Office Action Summary	Application No. 10/054,257	Applicant(s) BEAN ET AL.	
	Examiner Phong H. Nguyen	Art Unit 3724

DETAILED ACTION

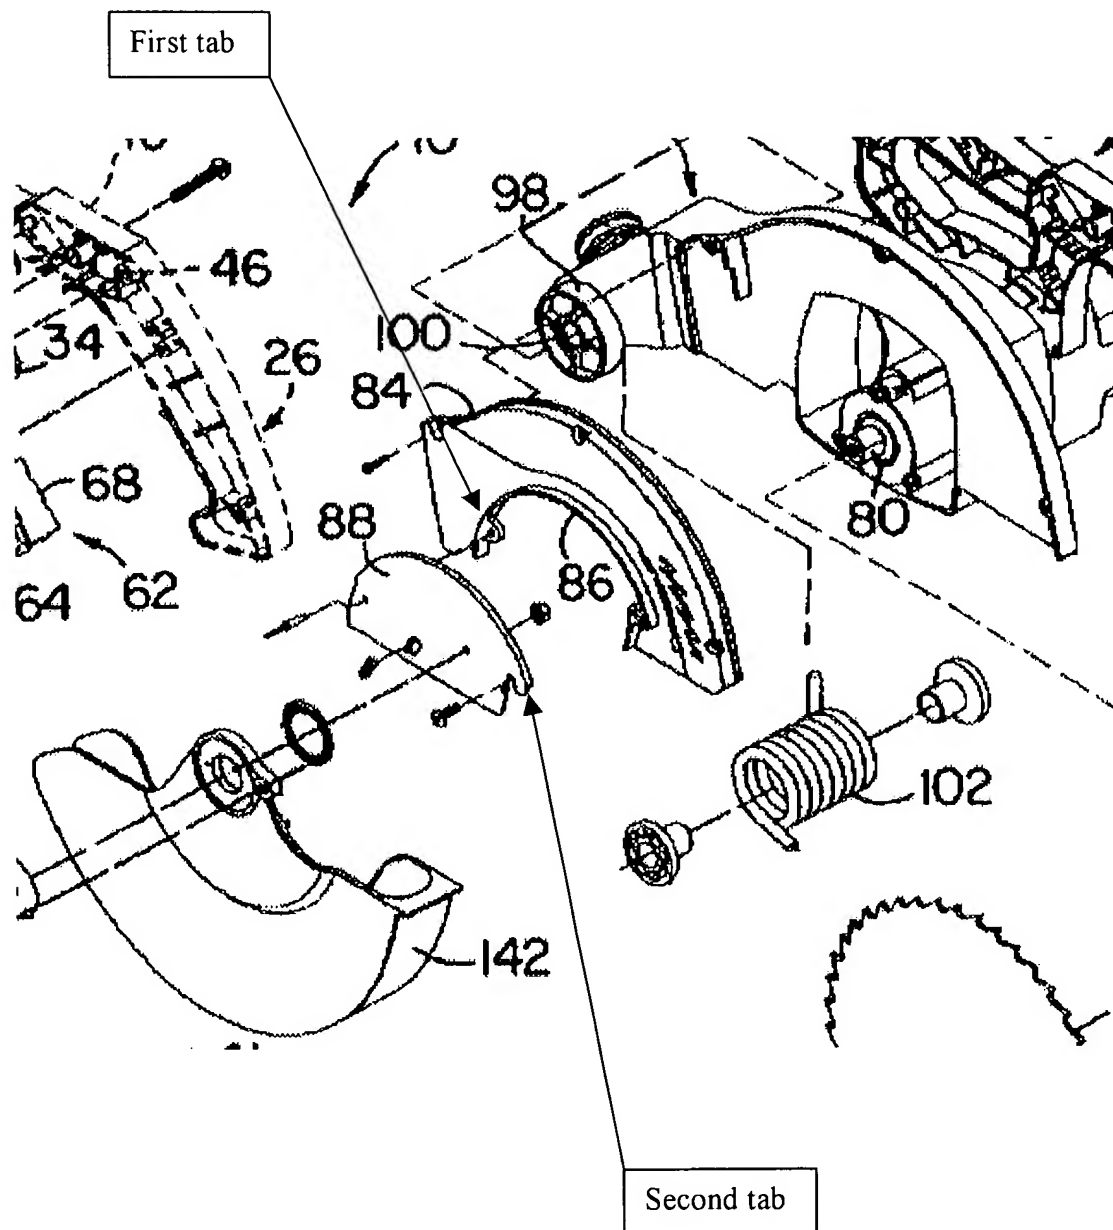
It is to be noted that since the fence assembly 20 is called both a fixed fence and a sliding fence and there is no other description of the fixed fence and the sliding fence in

the Specification, the Examiner calls the fence assembly 20 in Chang both a fixed fence and a sliding as the Applicant does so.

Chang teaches a miter saw comprising a base assembly, a turntable, a saw assembly, a fixed fence 22, a sliding fence 22 and a hole 215 for fixing an end stop fixture. See Figs. 1 and 2.
